November 7, 2024

RE: Site Plan Review for the Belmark Plant 5 Vestibule Addition at 675 Heritage RD
(Parcel ED-F0094-1)

Belmark Plant 5 - Vestibule

BELMARK PLANT 5 PARKING LOT ADDITION CITY OF DE PERE

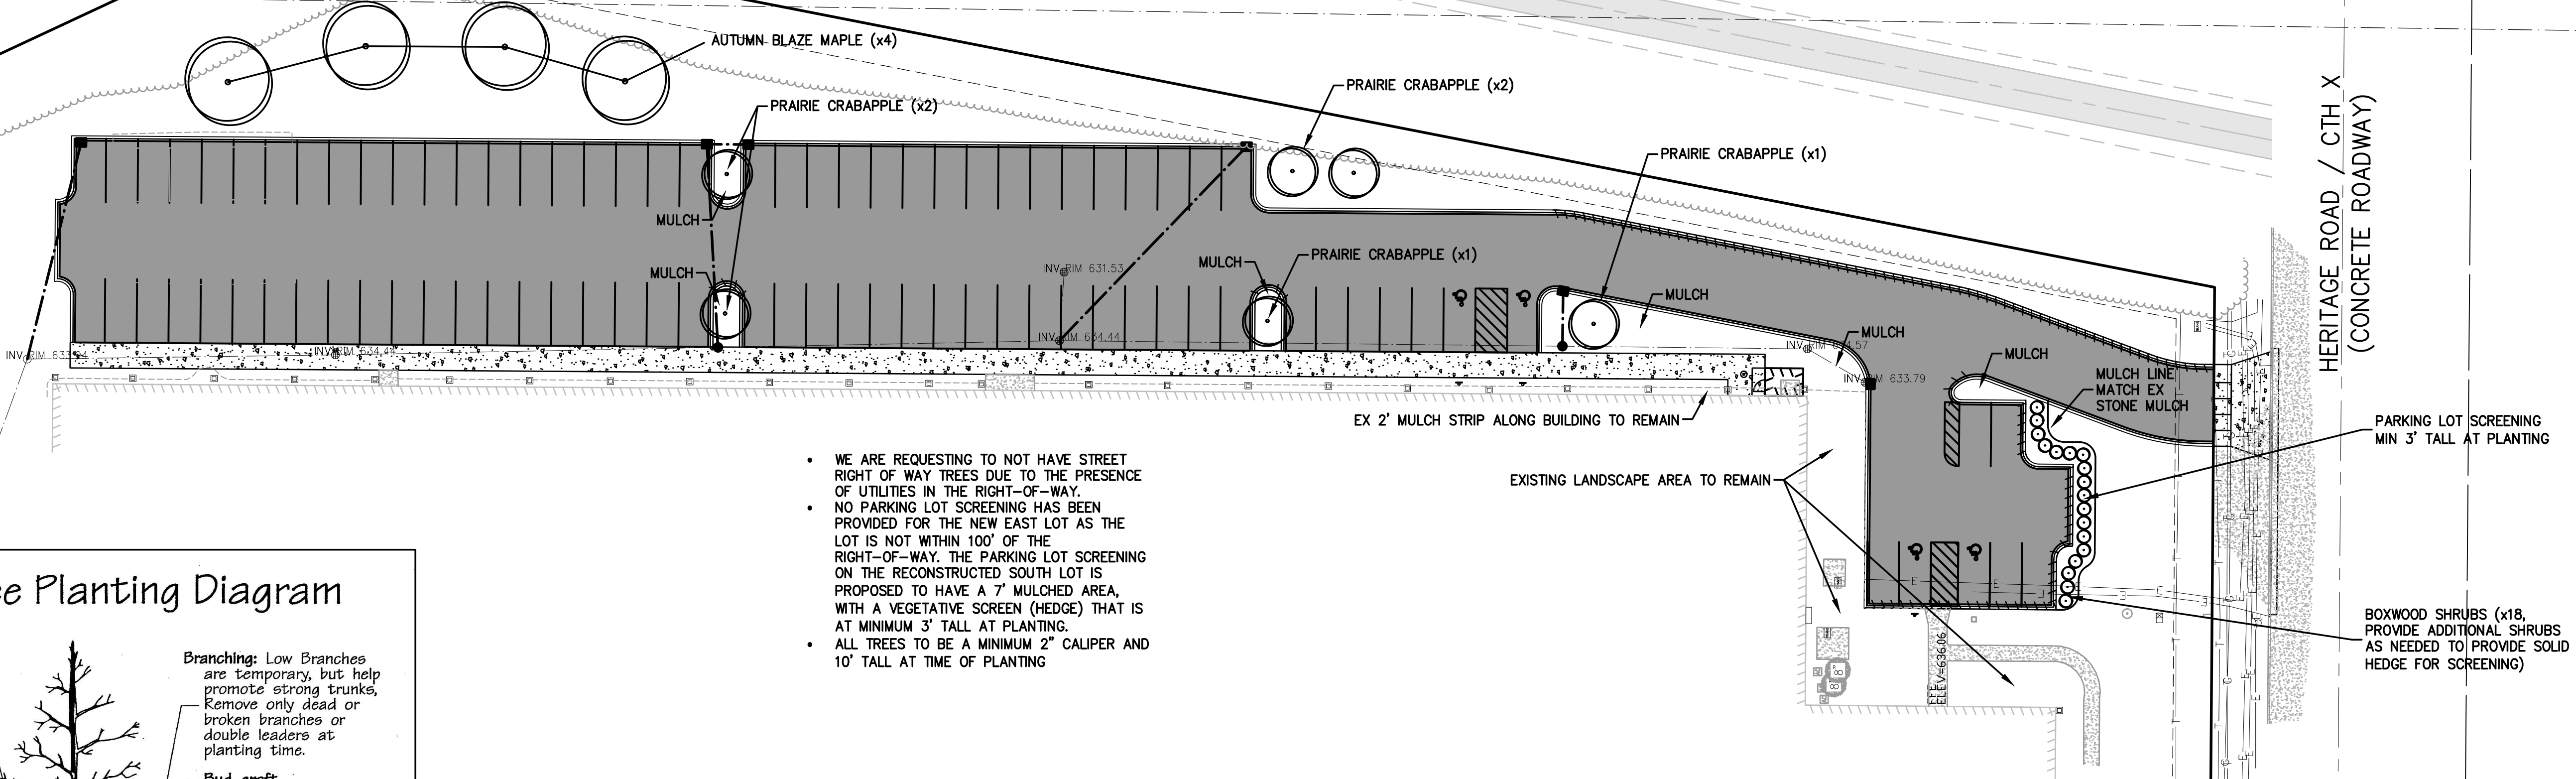
AFTER THE EXTERIOR LANDSCAPING IS INSTALLED, A STATEMENT FROM THE INSTALLER MUST BE PROVIDED TO THE CITY STATING THAT THE LANDSCAPING COMPLIES WITH THE APPROVED LANDSCAPING PLAN.
